RE: **Oso Bio Syringe Line**  
**4401 Alexander Blvd NE**  
**Grading and Drainage Plan for Building Permit**  
**Engineer's Stamp Date 11/1/2018 Disapproved**  
**Hydrology File: F16D003B1**

Re: Oso Bio Syringe Line Grading Plan Submittal; Hydrology File F16D003B1

Enclosed for your review is a copy of the Oso Bio Syringe Line Drainage Management Plan and Grading Plan Resubmittal. Below is a brief description of how the comments from your letter dated October 23, 2018 were addressed:

DRAWN BY:	DATE:
CHECKED BY:	PROJECT NO. 20190058
	SHEET NO. <b>C1.4</b>

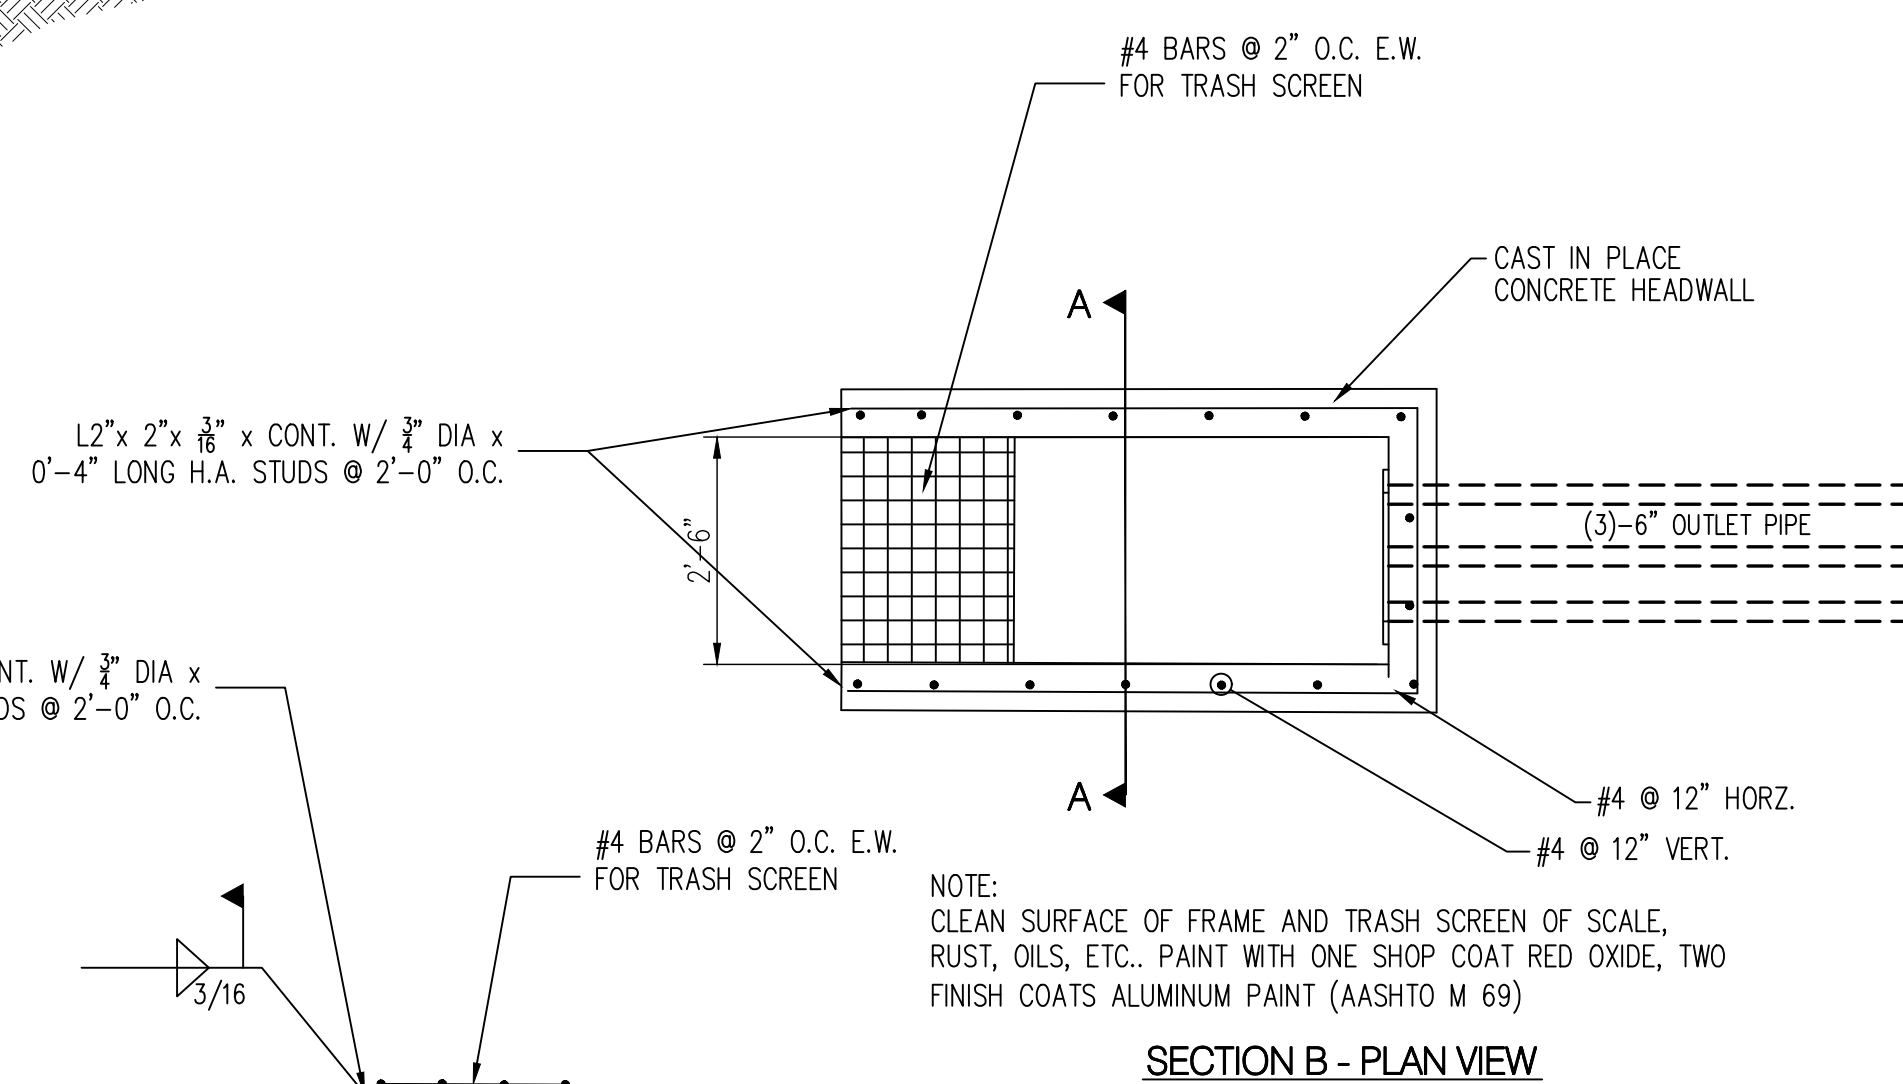
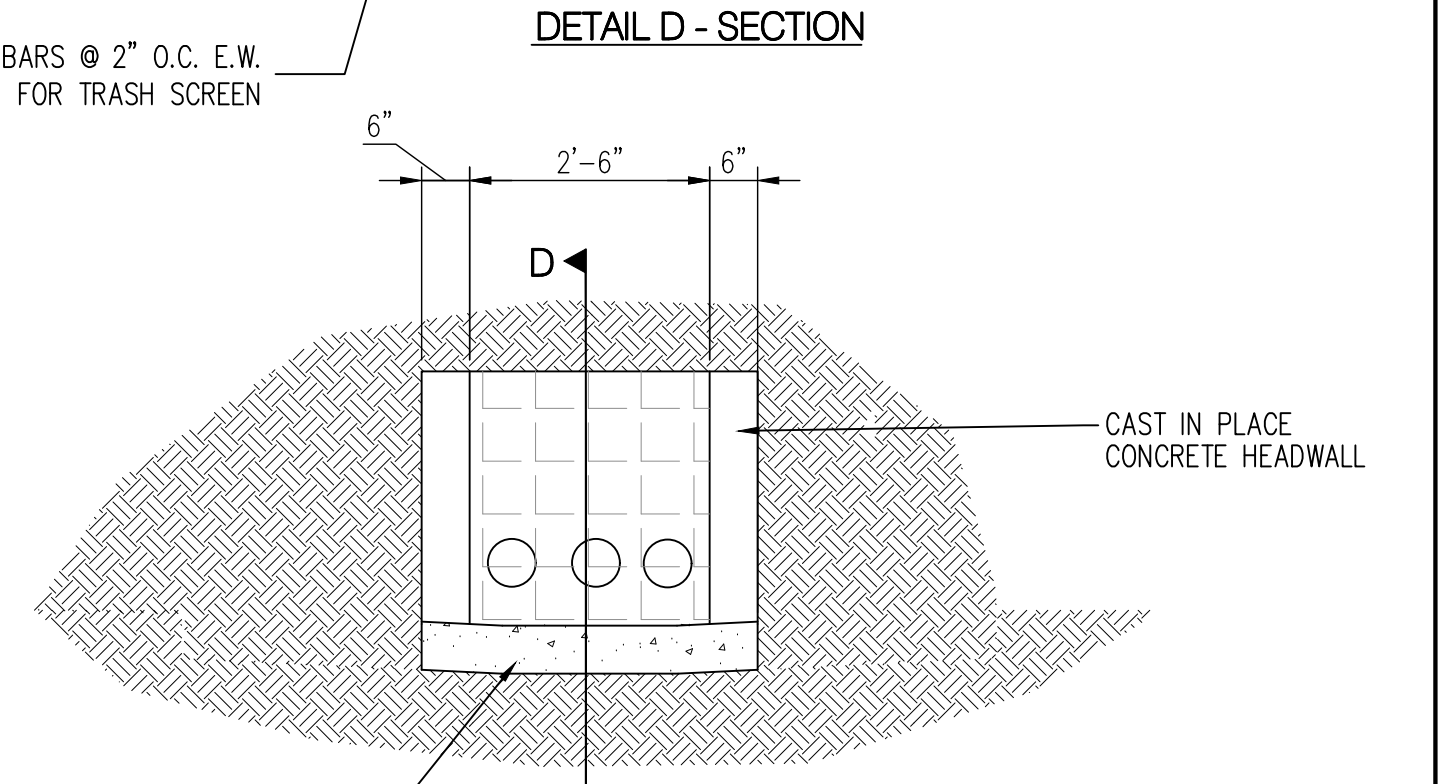
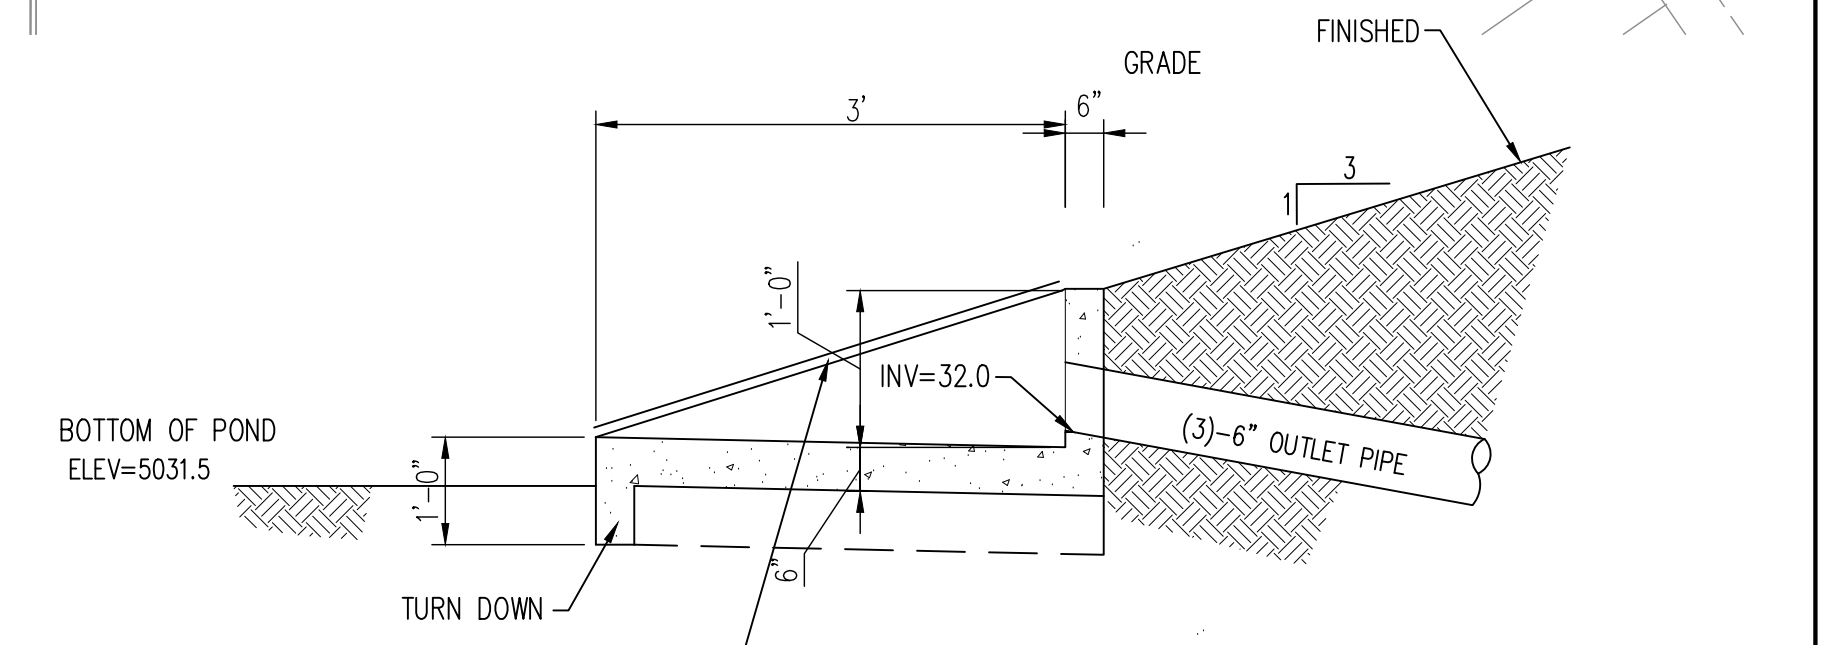
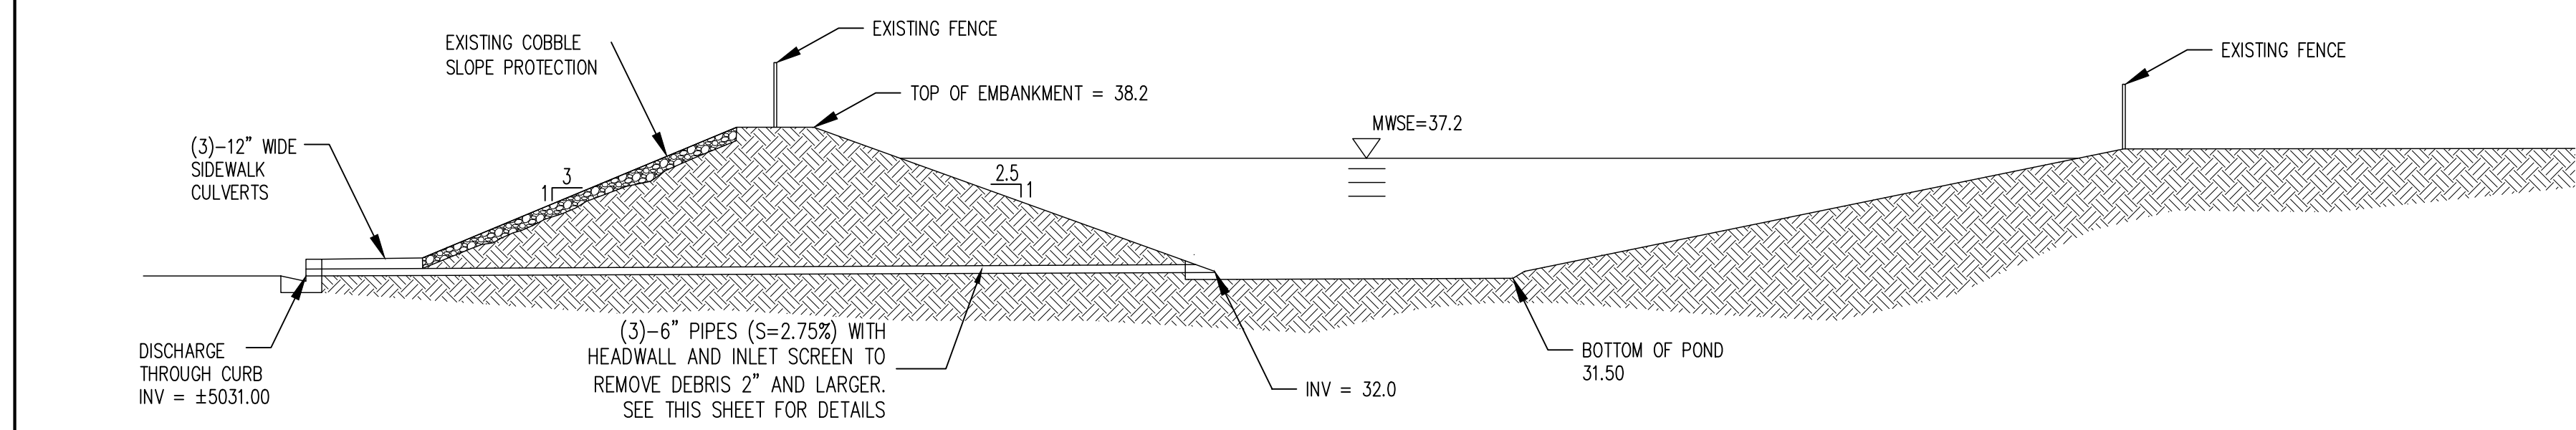
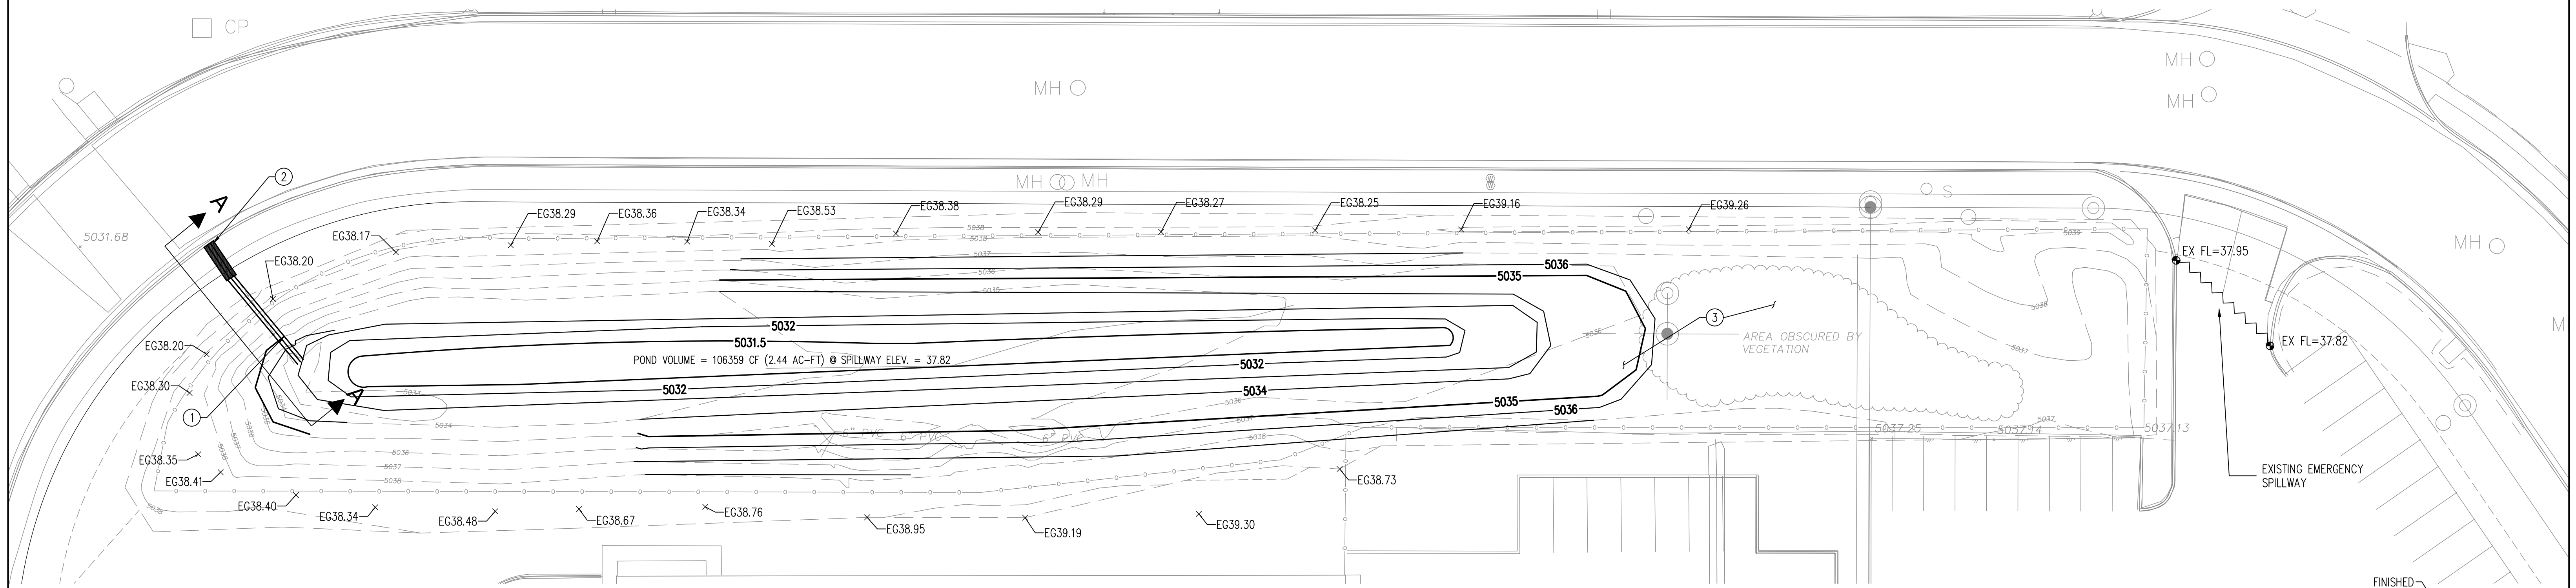
1. In the HEC-HMS Model:
  - a. Per the draft DPM, 6-1(B)(2) *Computation of Time of Computation*, if  $t_c$  is computed to be less than 0.2hrs, than use 0.2hrs. Lag time then becomes  $0.6 * t_c = 7.2$  minutes.
  - b. The inlet elevation for the PVC pipes is specified as 5033' but is 5032' in the plans.
  - c. The outlet elevation for the PVC pipes is specified at 5031.9' but is ~5031' in the plans; also the outlet elevation of the pipes and the Invert-In and Invert-Out of the sidewalk culverts should be specified on the plans.
  - d. The bottom of pond is defined as 5031' in the model, but shown as 5031.5' on the plans.
2. The proposed 100-yr WSEL needs to be shown on the pond in plan view.

4. Spot elevations from the survey have been added to the top of berm and spillway. The is shown on sheet C1.4. Transportation has agreed to allow the two northern driveways on the site to remain open if the owner will remove the concrete barriers. The owner has agreed to this. Spillway calculations are shown on the proposed DMP.

5. The MWSE has been added to the sections on both the plans and DMP. Keyed note 3 on sheet C1.4 notes to remove vegetation from the pond and embankment.
